Our Ref: N:\37672 Northbank\Worddocs\Report\Submission NSW DoPI 7 February 2013

NORTHBANK ENTERPRISE HUB (MP 10_0185)

Following the meeting on 31 January 2013 between the NSW Department of Planning & Infrastructure (DoPI), the Office of Environment & Heritage (OEH), Equatica, ADW Johnson, WBM BMT and NEH to discuss the general matters raised in these submissions, we now provide a response to each matter raised.

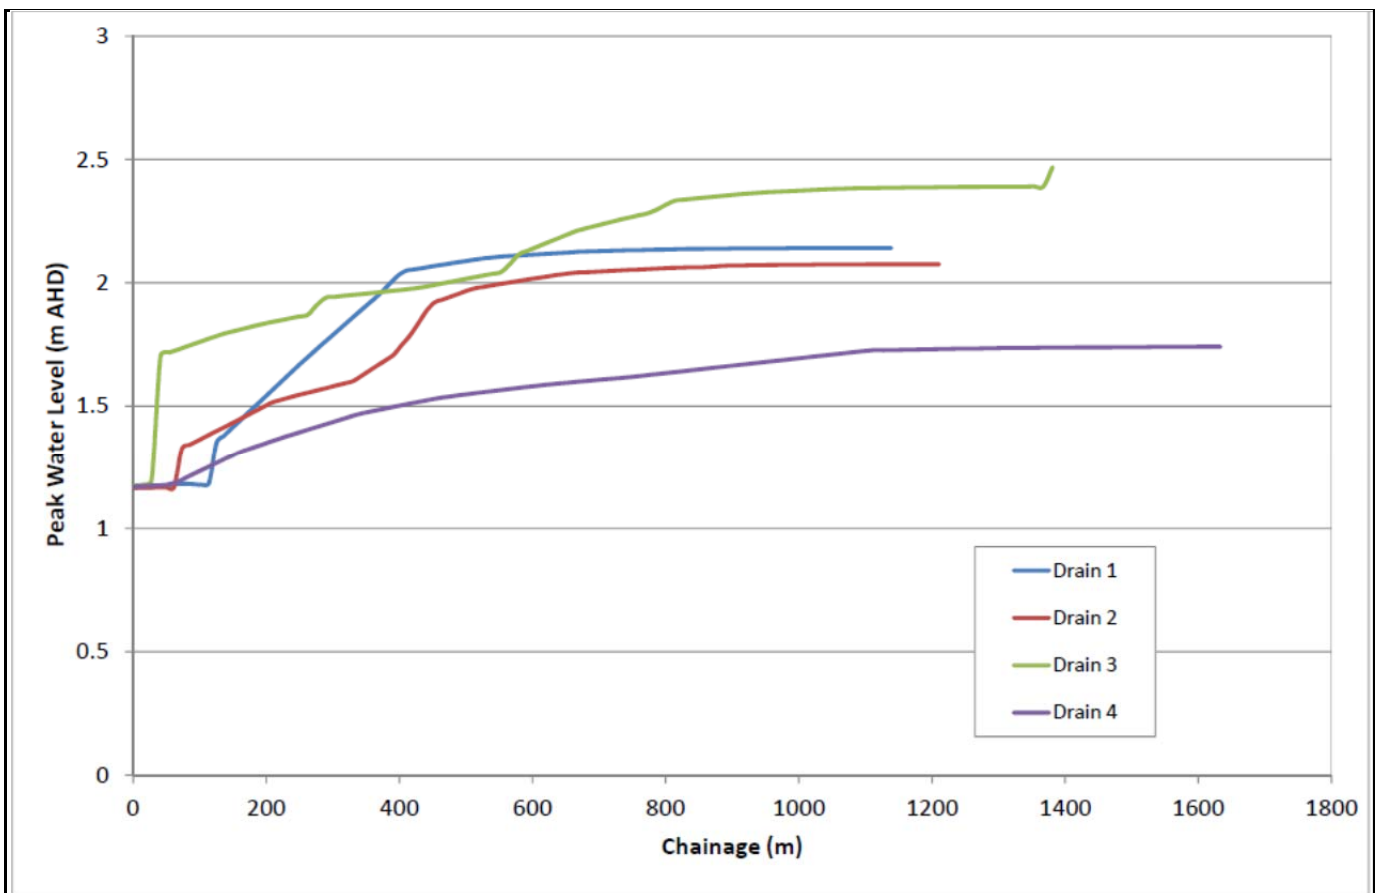
- *No mention has been made of increasing capacity of the existing flood gates.*

Upgrade of existing floodgates

The assumption is correct, no upgrade of the existing floodgates is proposed with the development of Lot 1001.
